DEVELOPMENT APPLICATION ASSESSMENT REPORT

Application Number:	DA2023/0868
Responsible Officer:	Claire Ryan
Land to be developed (Address):	Lot 44 DP 10648, 39 Hay Street COLLAROY NSW 2097 Lot 45 DP 10648, 41 Hay Street COLLAROY NSW 2097 Lot 46 DP 10648, 43 Hay Street COLLAROY NSW 2097 Lot 43 DP 10648, 37 Hay Street COLLAROY NSW 2097
Proposed Development:	Demolition of existing dwellings and construction of a seniors housing development
Zoning:	Warringah LEP2011 - Land zoned R2 Low Density Residential
Development Permissible:	Yes
Existing Use Rights:	No
Consent Authority:	Northern Beaches Council
Delegation Level:	NBLPP
Land and Environment Court Action:	Yes
Owner:	The Happy Bee Honey Company Ltd David Owen Mackenzie Lisa Anne Mackenzie Gai Lynne Shirley Stephens Craig Kenneth Charles Stephens Pretty Prinny Prop Pty Ltd
Applicant:	Daniel Michael McNamara
Application Lodged:	06/07/2023
Integrated Development:	No
Designated Development:	No
State Reporting Category:	Residential - Seniors Living

This development application seeks consent for demolition of existing dwellings and construction of a seniors housing development.

Above: The views from the main bedroom (left) and study (right) on the first floor at 32 Hay Street, from standing positions, looking north-east across the subject site.

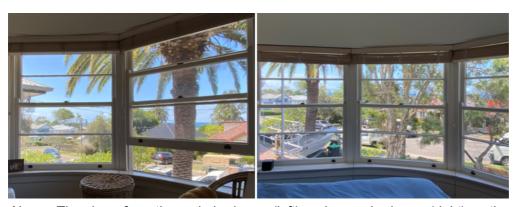
At the first floor level, the view is anticipated to be unaffected by the proposed development, given the bedroom and study on the first floor of 32 Hay Street is expected to look over the top of the built form.
